Firmware NEXUS_01_16_00.8 is available

For HP Latex 3x0 Printer Series

October 2019

Compatibility with the Configuration Centre application

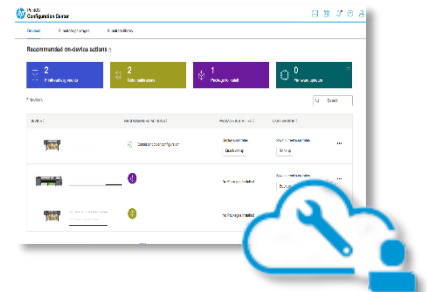
Possibility to set up the printer and manage the substrates configuration using the Configuration Centre.

Fix for the Take-up Reel button grayed out in the Front Panel menu after Firmware upgrade

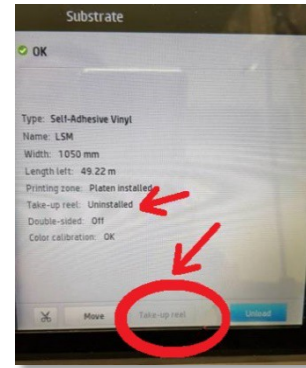
This firmware permanently solves the issue with the Take-up Reel button on the Front Panel becoming inaccessible.

There was a known issue which mainly appeared after upgrading the firmware to the previous version (NEXUS_03_14_00.8). The Take-up Reel button on the Front Panel became grayed out, inaccessible.
